122nd session

Proposal for a new UN Regulation on uniform provisions concerning the approval of motor vehicles with regard to their Direct Vision

Submitted by the Informal Working Group on Awareness of Vulnerable Road Users proximity in low speed manoeuvres*

Figure 2: Definition of Assessment Volume

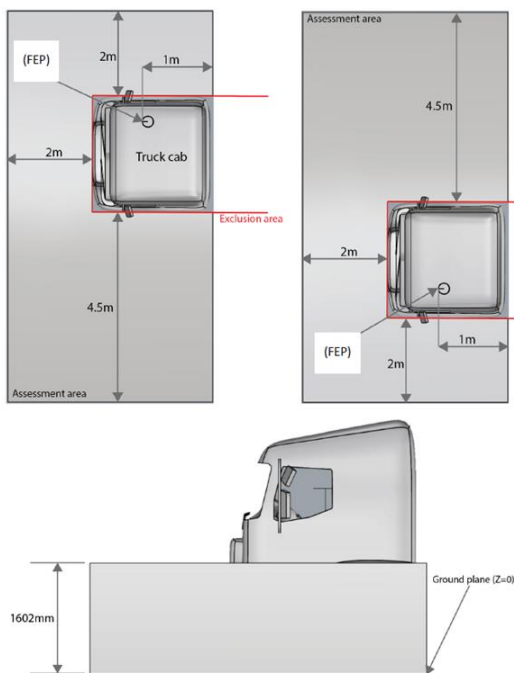
Met opmerkingen [IK21]: Needs revision – exclusion zone is frontal plane, nearside plane etc FEP is E2. Arguable we could more neutrally represent front portion of vehicle (m2, m3, N2, N3) as now defined in text rather than truck specifically. Though truck is of course a valid example

Figure 1:

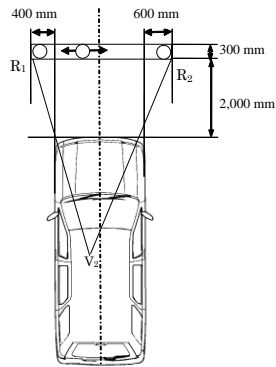
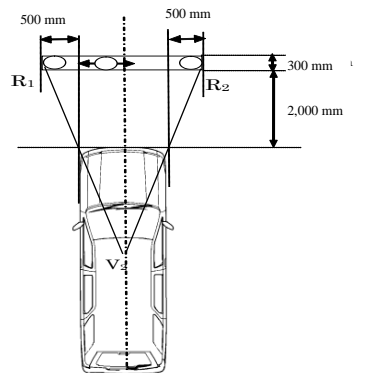
Met opmerkingen [IK22]: Correct figure refs and title
